NOTICE OF MEETING

The City of Lake Elmo
Planning Commission will conduct a meeting on
Monday March 28, 2022
at 7:00 p.m.

TO: Planning Commission
FROM: Corrin Bemis, Planning Consultant
AGENDA ITEM: **Setback Variance Request at 9404 Lake Jane Trail N**
REVIEWED BY: Molly Just, Planning Director

TO: Planning Commission
FROM: Molly Just, Planning Director
ITEM: H.C. Golf Land, LLC Conditional Use Permit for a Swimming Pool & Fitness Center

LEGEND

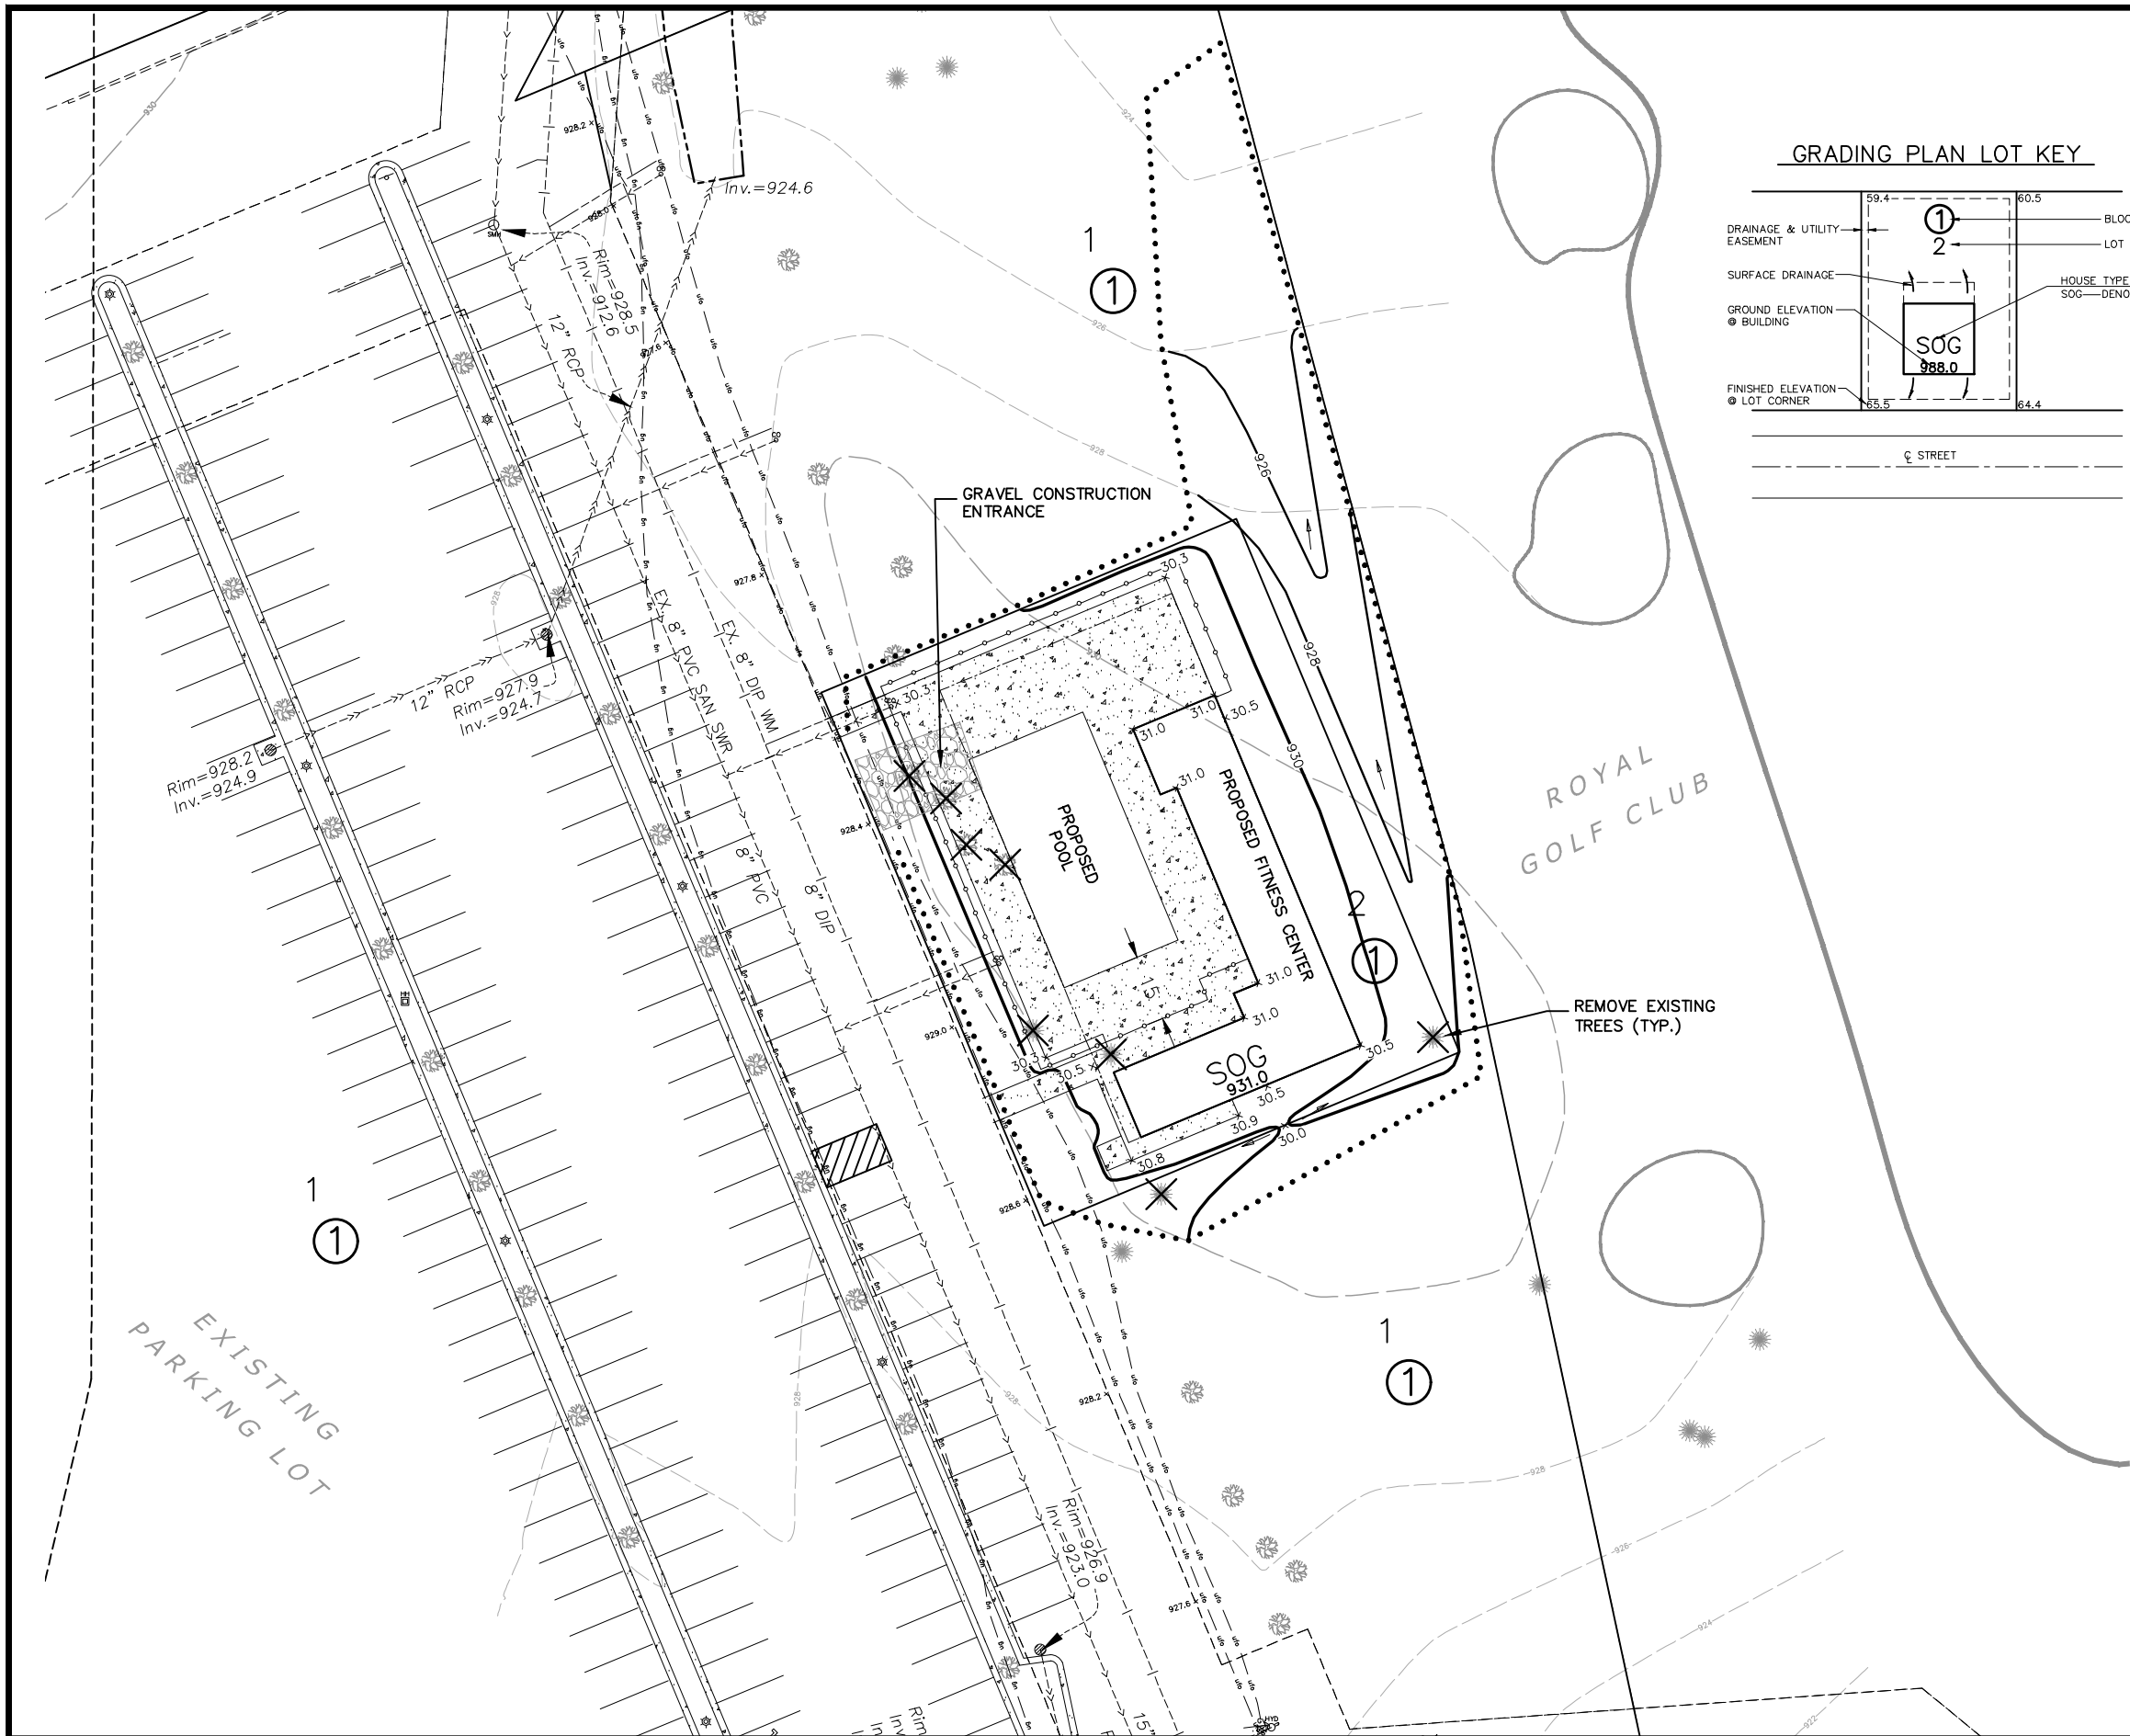
Engineering Review. The City Engineer reviewed this request and prepared the following response.

1. For city record purposes, the application drawings should be updated to provide an additional project location plan that provides the proposed facility location with respect to existing property lines, parcel data and easements. All property and easement line types should be clearly labeled.

6. Stormwater Management. The applicant must identify whether stormwater management will be required for the improvements. VBWD requirements trigger stormwater management for 6,000 SF of impervious surface area. If additional stormwater management is needed, a site grading plan will need to be reviewed and approved by engineering prior to construction.

3. Prior to issuance of City permits for the proposed swimming pool or fitness center the applicant must identify whether stormwater management will be required for the improvements. VBWD requirements trigger stormwater management for 6,000 SF of impervious surface area. If additional stormwater management is needed, a site grading plan shall be reviewed and approved by engineering prior to construction.

STANDARD DRAWING NO.
LP2.0
LAKE ELMO

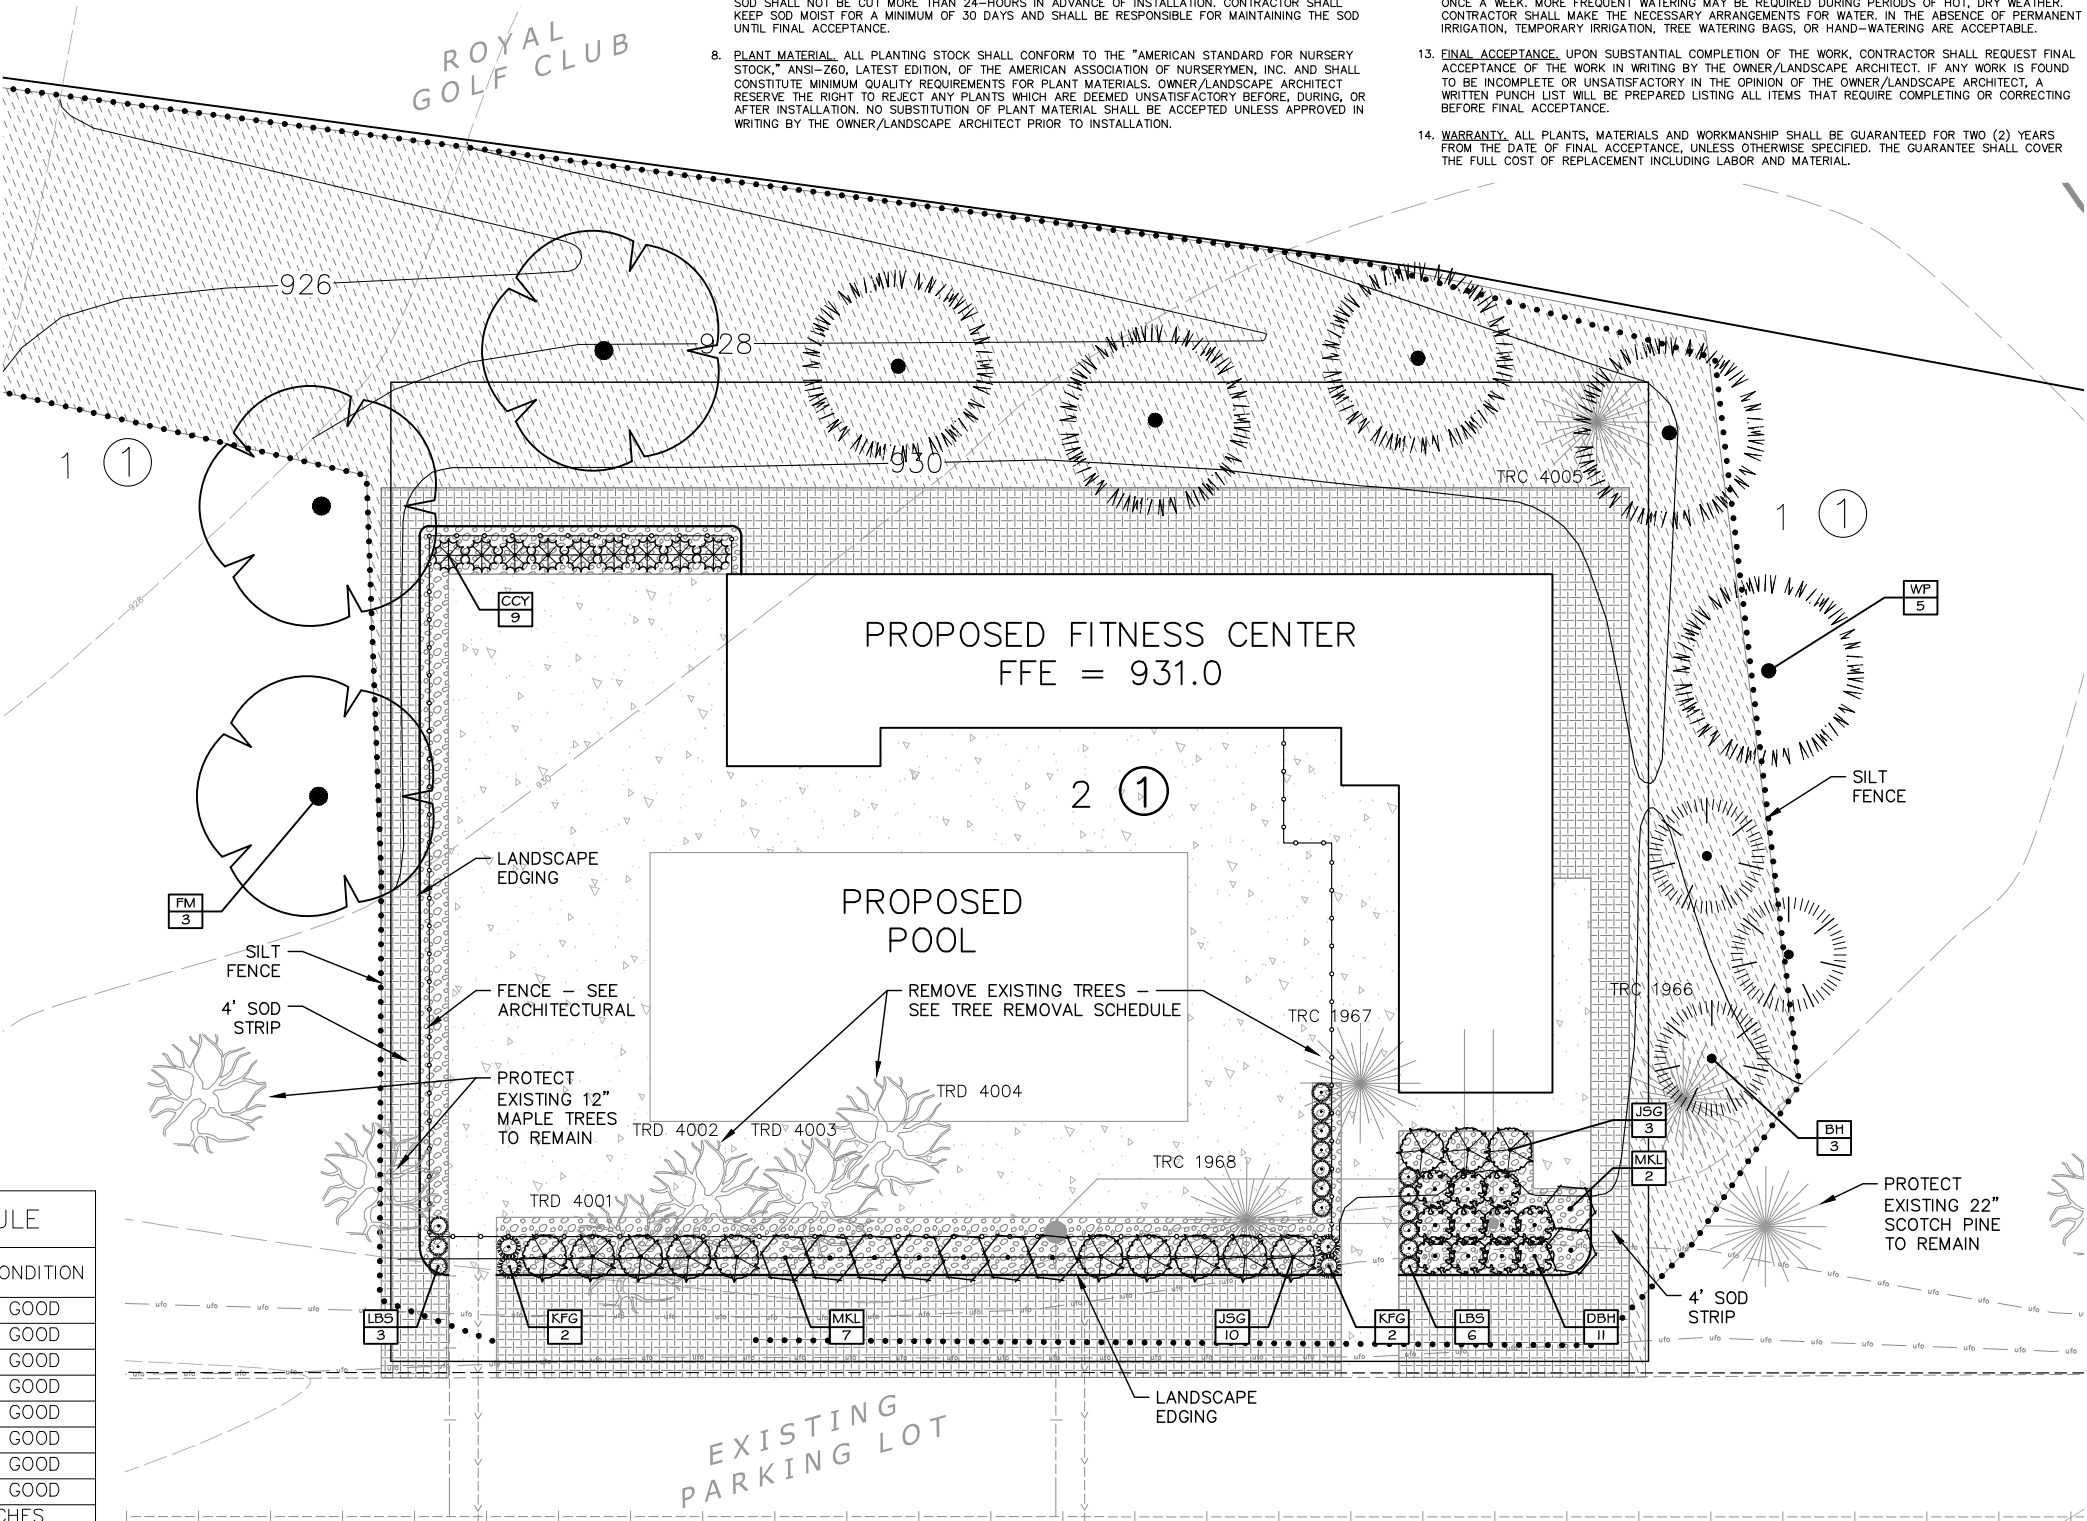
A landscape/tree preservation plan has been submitted that does not meet all requirements.

- The Tree Preservation Plan must include a Tree Inventory, which includes:
 - A listing of healthy significant trees inventoried
 - A listing of the healthy significant trees removed

- A listing of the healthy significant trees to remain
- The landscape and tree preservation plans currently does not list an inventory of trees to remain

- Measures to protect significant trees. Silt fence is shown on the plan but is not a sufficient tree protection measure. Refer to the City tree protection detail and definition of Critical Root Zone for locating tree protection fencing.

- One existing 12-inch Maple tree and 22-inch Scotch Pine are noted to remain but are shown to be in conflict with proposed construction impacts within their Critical Root Zone (CRZ). The CRZ, as defined by the City Code, is not shown on the plan.

A landscape plan has been submitted that does not include all requirements

- All plant materials shall meet the minimum size standard per Table 6-1. For example, deciduous shade trees shall be 2.5-inch caliper minimum.

- Current plans show the required number of trees but does not meet the 6-ft height, 90% opacity portion of the screening requirement.

Irrigation – The plans do not include detail on whether the irrigation system design will include a new point of connection.

2. Prior to issuance of City permits for the proposed swimming pool or fitness center the landscape plan shall be revised and found compliant with Article VIII.

- Submit a revised landscape plan and tree preservation plan.
